## SERVICE BULLETIN Amateur Radio Division

SUBJECT TS-940S MRF-485 Driver Transistor Notes

DATE January 16, 1992

Kenwood, U.S.A.	
2201 E. Dominguez Street	
Long Beach, CA 90801-5745	
Title TS-9405 MRF-485 Driver Transistor	
Size	Document Number
A	SB-968
Date:	January 31, 1962 Sheet 1 of 2
REV

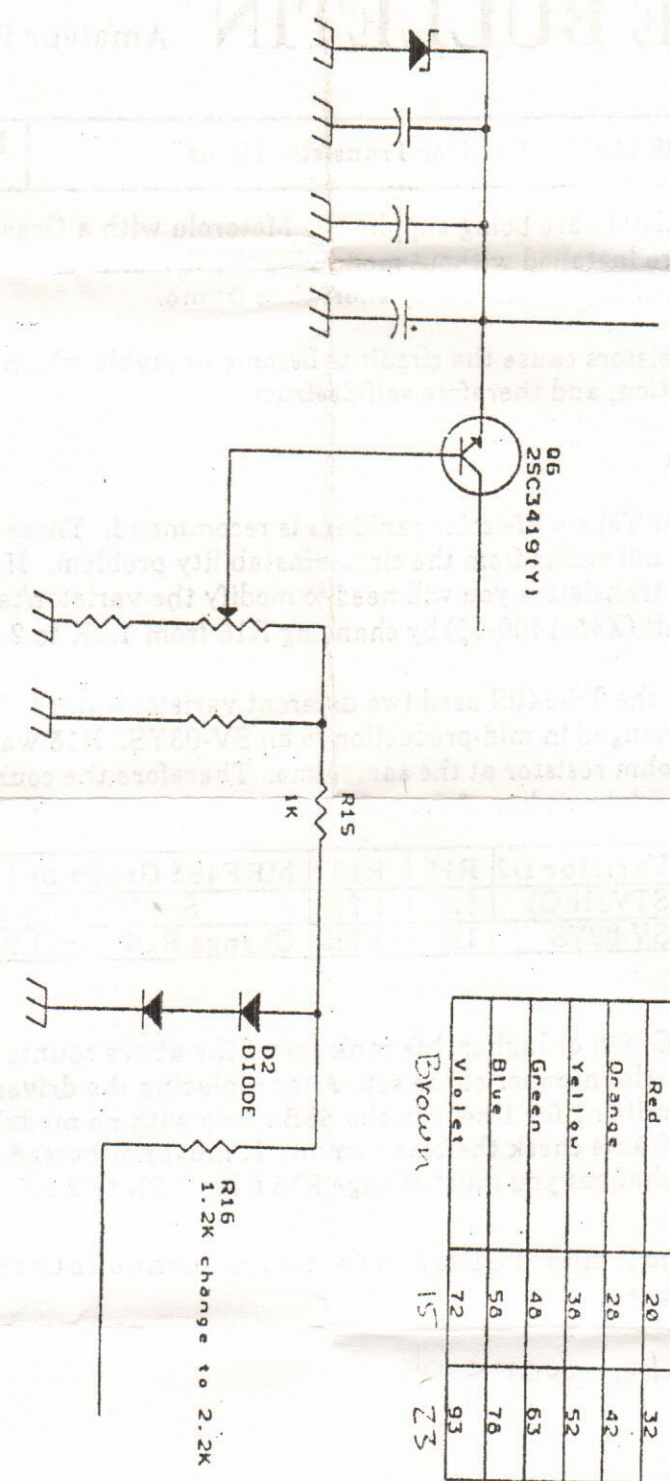
Some MRF-485 transmitters are being furnished with a Green or Blue color banding. These transmitters are identical to the standard MRF-485 transmitter except for the color banding.

These high gain transmitters cause the circuit to become unstable which can cause the circuit to break into self oscillation, and therefore self destruct.

Use of Red Orange or Yellow color banding is recommended. These lower gain transmitters work just fine and do not cause the circuit to become unstable. If you are only able to obtain the higher gain transmitters, you will need to modify the circuit to compensate for the higher gain.

Some of the products of the 7-4-62 used two different color bands. The original part was an ST-501, which was changed in mid-production to a 5V-481. The 5V-481 was changed to a 5V-482. Therefore the color banding is different.
